# CANTUNG MINE RECLAMATION COST ESTIMATE

### Indian Affairs & Northern Development Water Resources Division Yellowknife, Northwest Territories

### **Brodie Consulting Ltd.**

November, 2002

Photograph 1 View of Flat River tailings

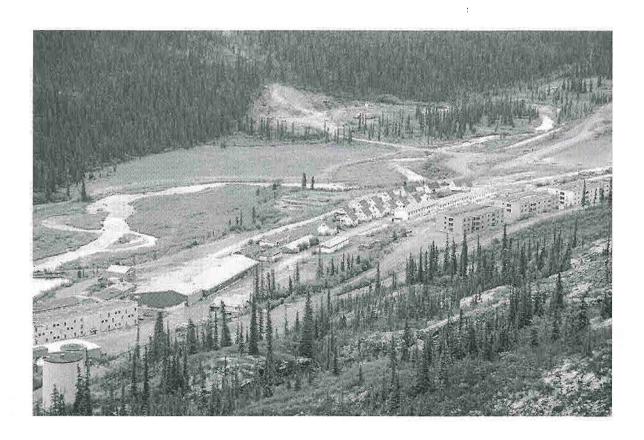
Flat River is a naturally meandering river. As can be seen at the right side of Photograph 1, Flat River has already cut one meander path through the old tailings. This meander is not evident in the airphoto on the wall in the Cantung Mine office.

Its path is likely to continue to change in the future and continue to erode the deposited tailings. The limited rip rap erosion protection which has been placed on some bends in the river will not prevent the river from meandering in the future.

There has not been an impact or risk assessment presented to show that leaving these tailings where they are is acceptable, either now or in the long-term. Therefore, it is assumed that this material should be removed from the river, amended to reduce current levels of acidity and mobile metals, and placed in a secure containment which prevents future acid generation.
